Manual Supplement

Manual Title:	744 Users	Supplement Issue:	6
Part Number:	691287	Issue Date:	4/06
Print Date:	September 1998	Page Count:	8
Revision/Date:	1, 2/99

This supplement contains information necessary to ensure the accuracy of the above manual.

Figure A. Sourcing Temperature using Drywell

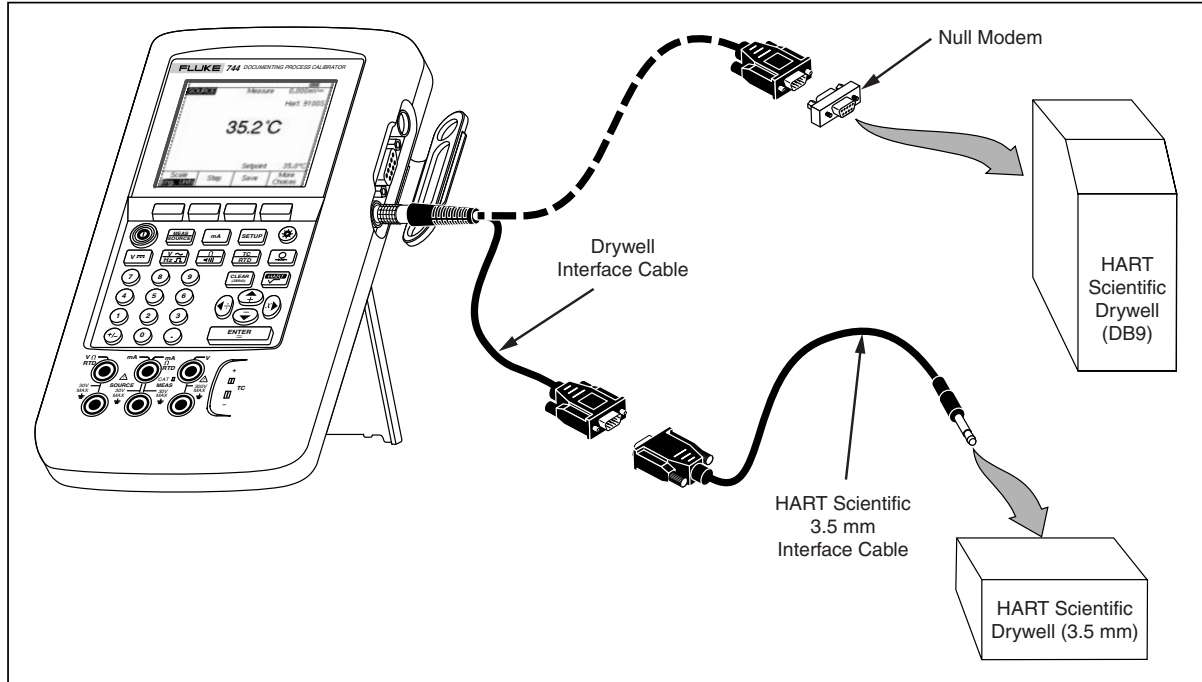
On page 59, before **Source Scale**, add the following:

Connect the 744 to the drywell by plugging the drywell interface cable into the pressure module connector as shown in Figure A. If the drywell has a DB9 connector, plug the drywell interface cable directly into the drywell using the DB9 Null Modem adapter. Drywells with the 3.5 mm jack connector need to use the serial cable supplied with the drywell in addition to the 744 drywell interface cable. Join the DB9 connectors of the two cables, and connect the 3.5 mm jack to the drywell.

Be sure the drywell is configured for serial communication at 2400, 4800, or 9600 bits per second. Other rates are not supported by the 744.
